Revised Pad Size Re: NMSLO
request

From: Brian Wood <brian@permitswest.com>
Sent: Monday, December 30, 2019 11:47 AM
To: Rose-Coss, Dylan H, EMNRD
Cc: Blake Morphew
Subject: [EXT] BAM's Linley State SWD 1

LINLEY STATE 001H
Section 32 T15S R29E NMPM
Chaves County, NM

DWG. NO. : 11351-L01		REVISION: 2
DRAWN BY: H.J.	DATE DRAWN: 5/15/19	REV. DATE: 12/10/19
SURVEYED: 05/02/19	APP. BY: M.W.L.	SHEET: 1

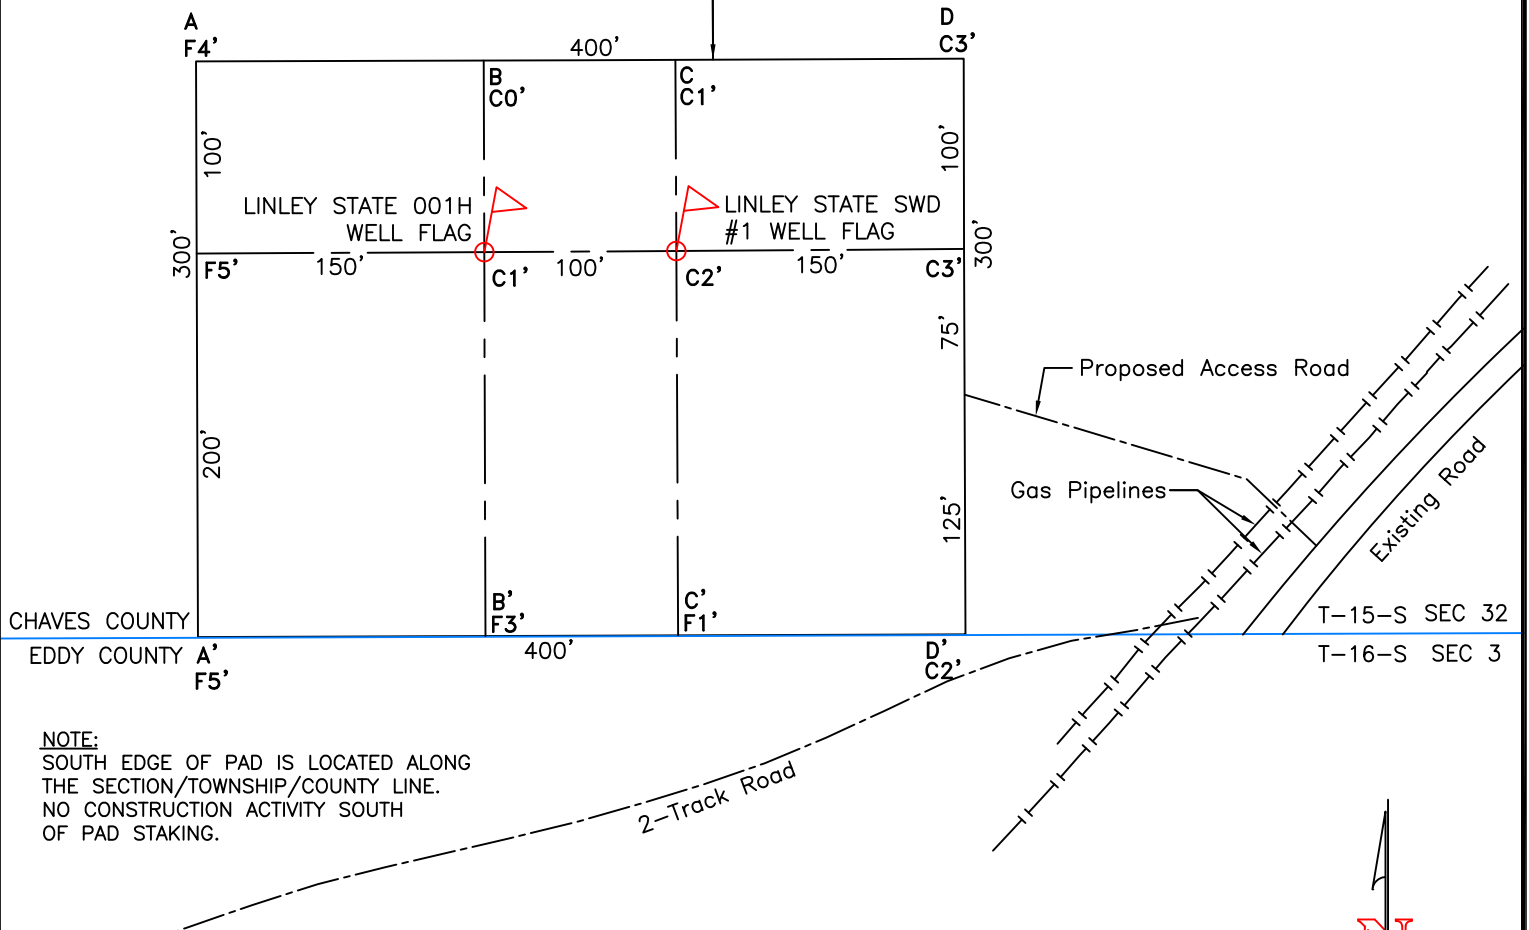
BAM has re-staked its Linley State pad and road.

BAM trimmed 100' off north side of pad.
This reduced pad from 400' x 400' to 300' x 400'.

BAM shifted road south 75'.
The reduced length by 82.2'.

Does this resolve the NMSLO San Andres & topographic concerns?

Brian and Blake,
Yes the subsurface concerns highlighted by the SLO are resolved as well.

Thank you for your efforts. This re-stake will satisfy the State Land Office request for re-siting further back from the playa.
